Addendum No. 2

City of Coquitlam

Tender No. 87424

North Road Watermain (Como Lake Ave – Chapman Ave)

DRAWING NUMBER:
COQ-W2m

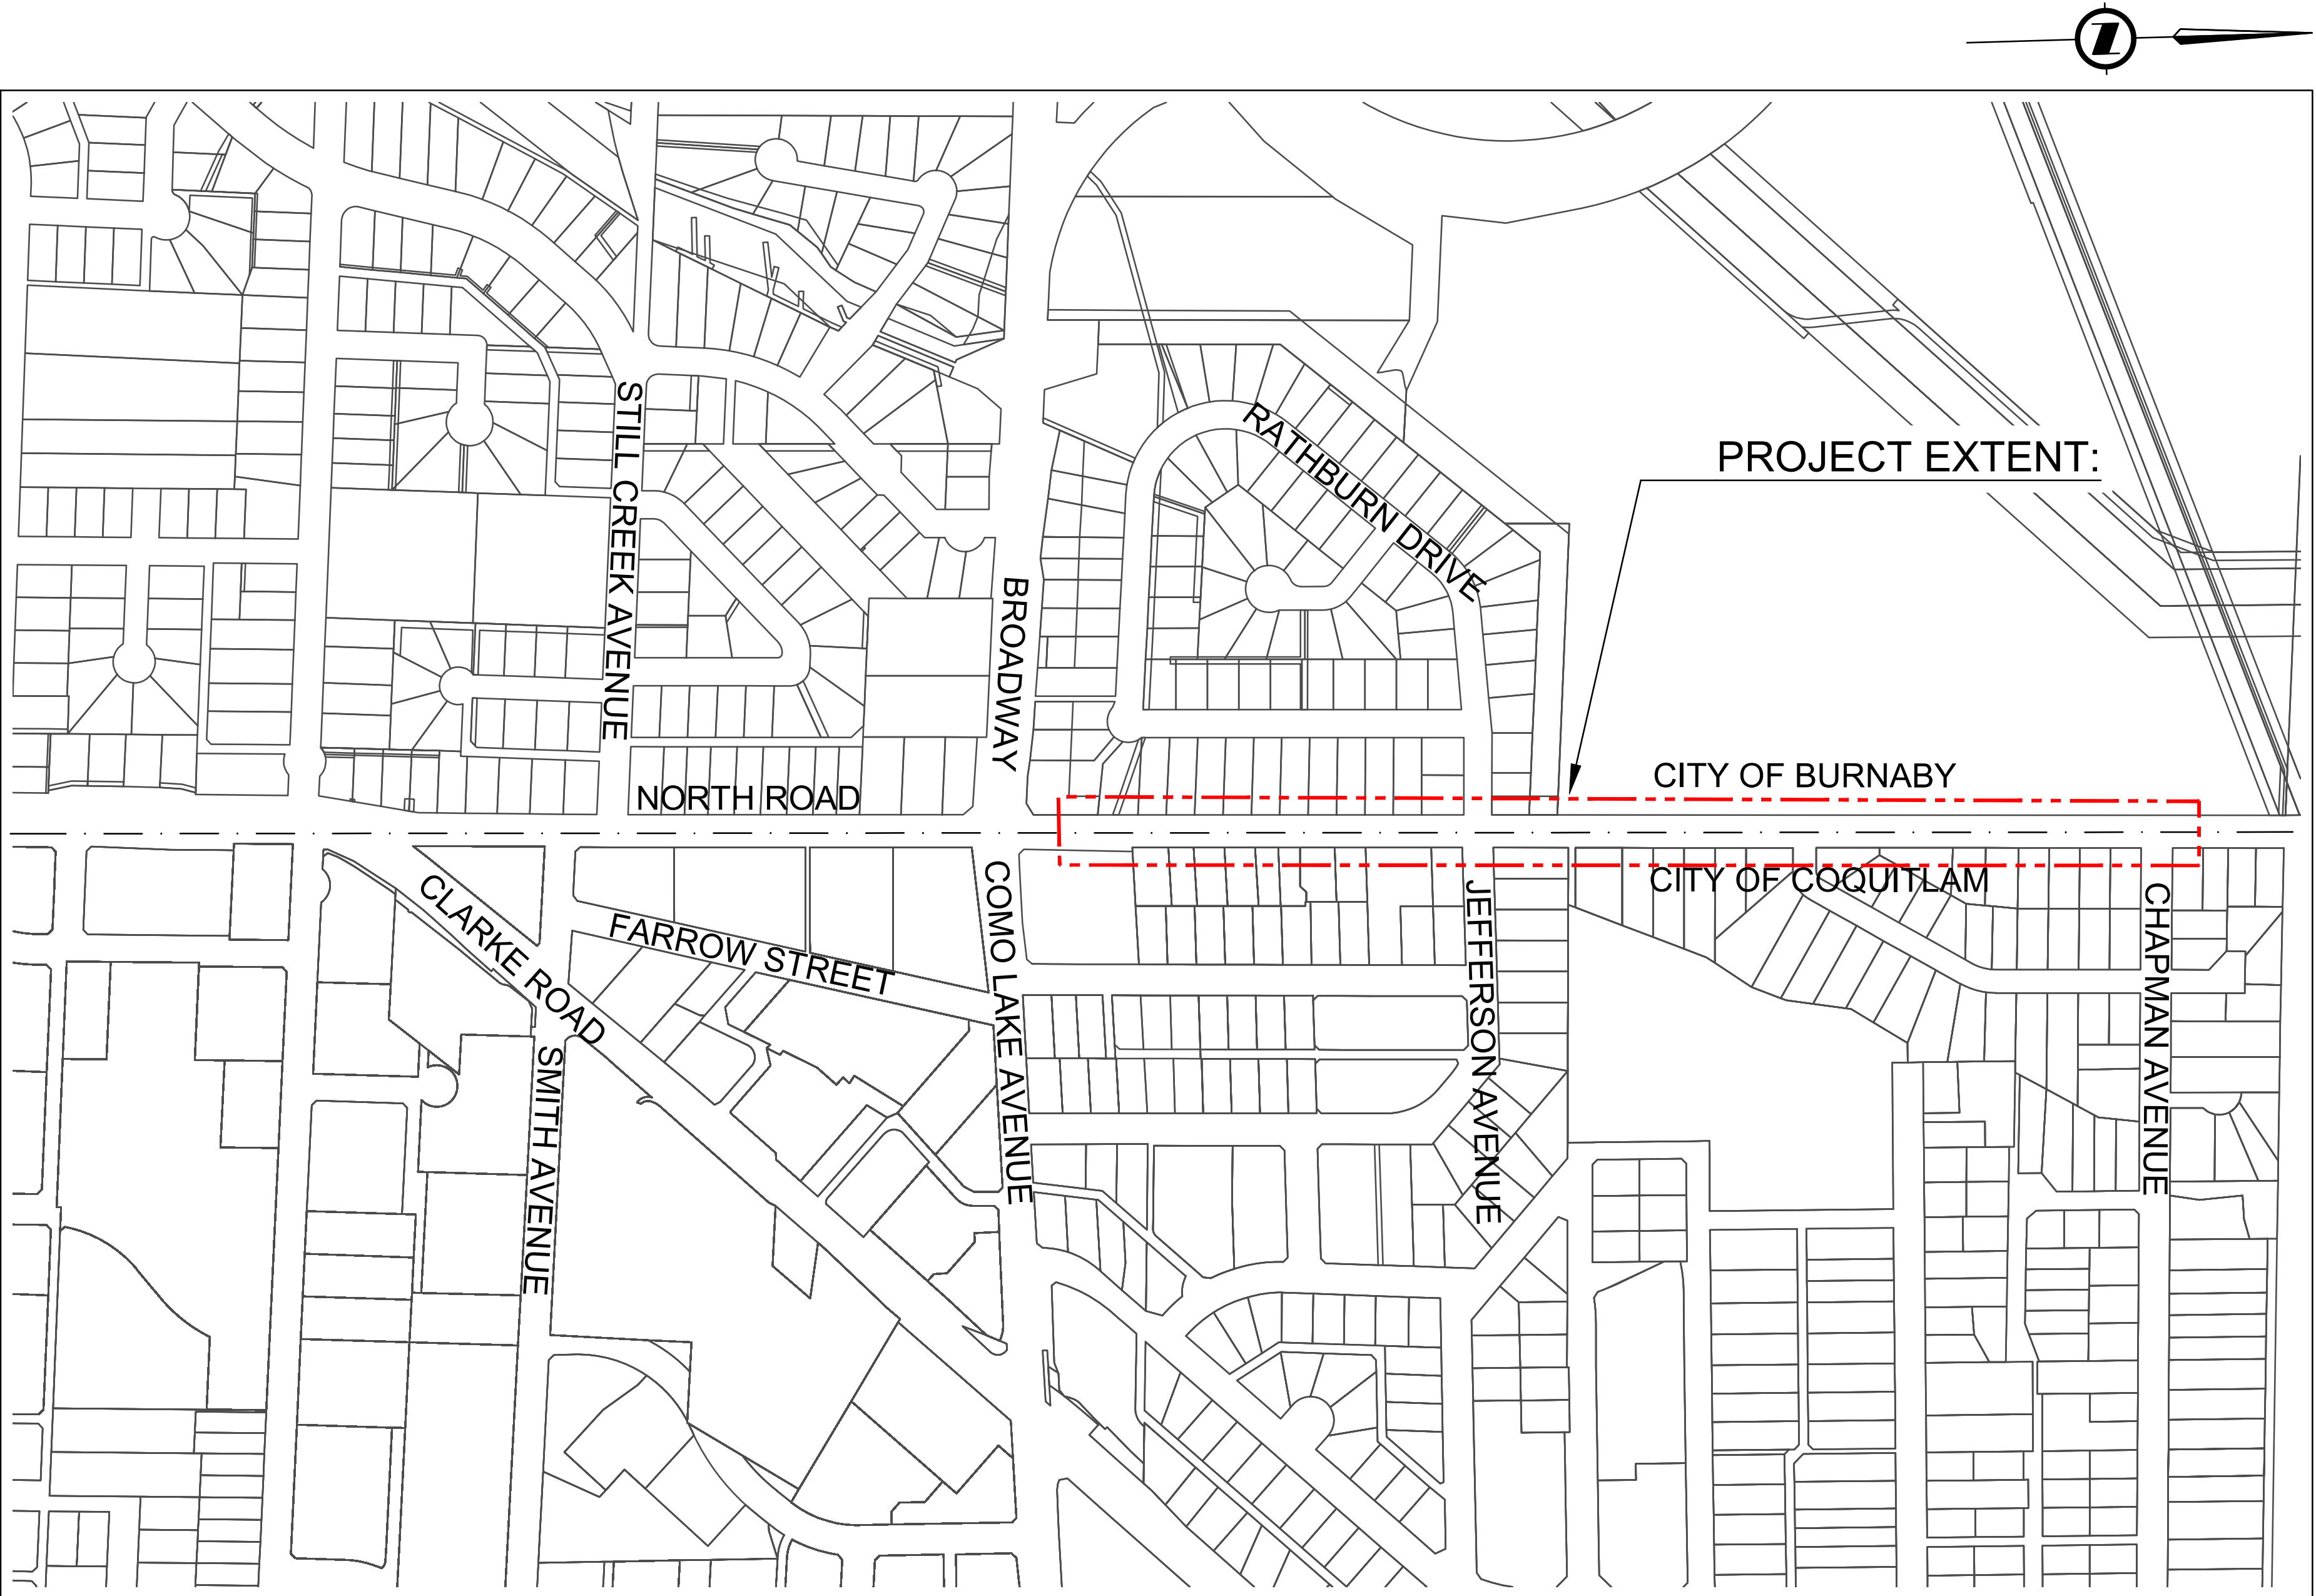
3. Refer to: APPENDIX C – Standard Detail Drawings

DELETE: WM-2

ADD: COQ-W2m

A1: No, new water meters will not be required. Only meter setters as per COQ-W2m.
